Removing Odometer Pause Wiring Modifications

TSB-54-100-WST

For vehicles with Common Powertrain Controller (CPC5) software installed prior to January 9, 2024, hardware and software modifications were necessary to allow vehicle speed and mileage sensors to be ignored during split shaft Power Takeoff (PTO) operations. This bulletin applies to Freightliner and Western Star vehicles equipped with Detroit® engines and the CEEA+ architecture.

Figure 1 shows the modification diagram for the system to be removed.

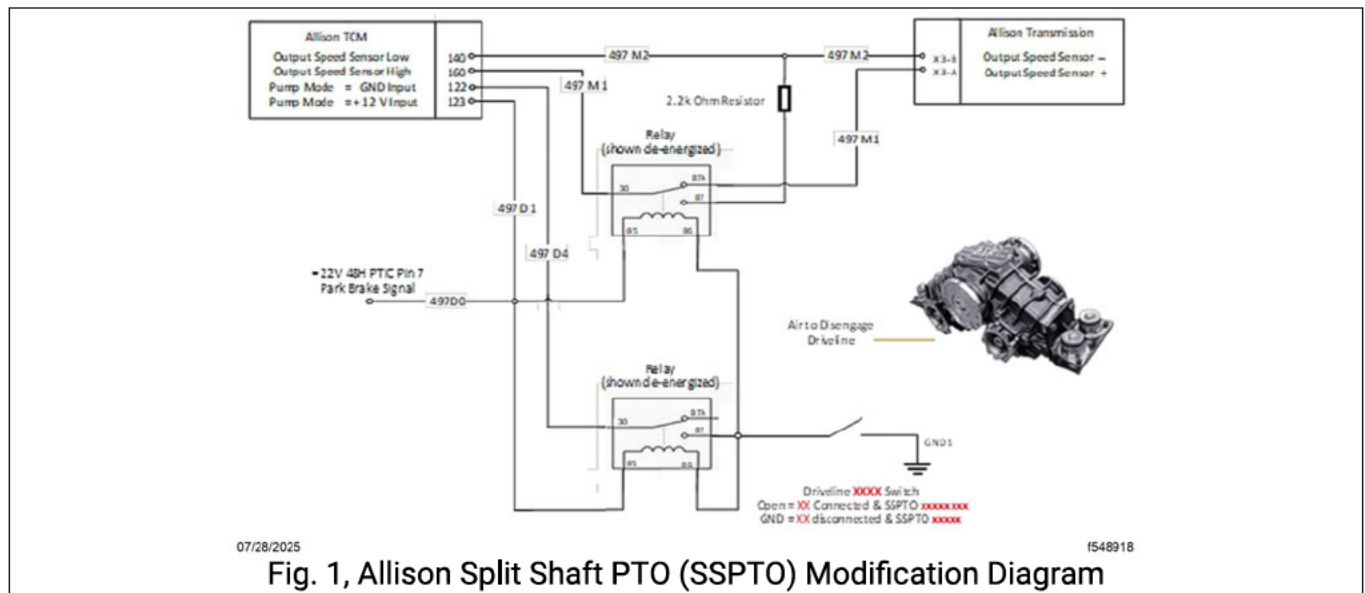
This section describes how to rewire the Allison Output Shaft Speed (OSS) sensor to the Original Equipment Manufacturer (OEM) configuration.

❗ Note: With the relays removed, the control signals, directed to the park brake signal node, and the driveline disconnect switch are to be connected to the Allison Transmission Control Module (TCM) pins 122 and 123. Control signals to TCM 123 and 122 are to be re-established. The two relays no longer sequence signals to the TCM.

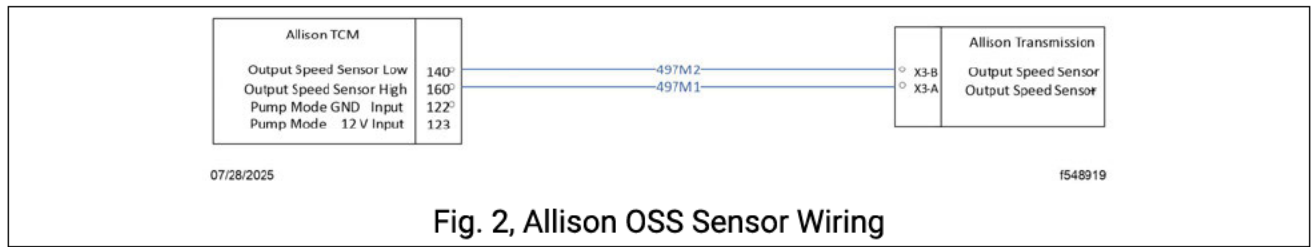
1. ☐ Remove the 2.2K ohm resistor. Leave the circuit 497M2 intact.

2. ☐ Remove both ends of 497M1 from the relay and connect 497M1 again. Leave the TCM pin 160 and the output speed sensor pin X3-4 intact. The final configuration is shown in Fig. 2.

3. ☐ Remove the remaining relay for the driveline status. Keep the wires 497D1 and 497D4 intact. These wires connect to the TCM pins 122 and 123 and are re-used.
4. ☐ After the relay circuits are removed, the fourth gear lock-up function needs to be enabled by sending power to TCM 123 and a switch to ground for TCM 122 when the driveline is disengaged, and the SSPTO is engaged.
- TCM 123 reflects the selection of pump mode by the operator and the application of the park brake.
 - TCM 122 indicates that the split shaft PTO is fully engaged, and the driveline is disengaged.
5. ☐ After removing the relay circuits, for instructions to set the Single Signal Detect and Actuation Module (SSAM) and CPC5 parameters for the odometer pause function, see **TEM-54-00012: Odometer Pause for SSPTO**.
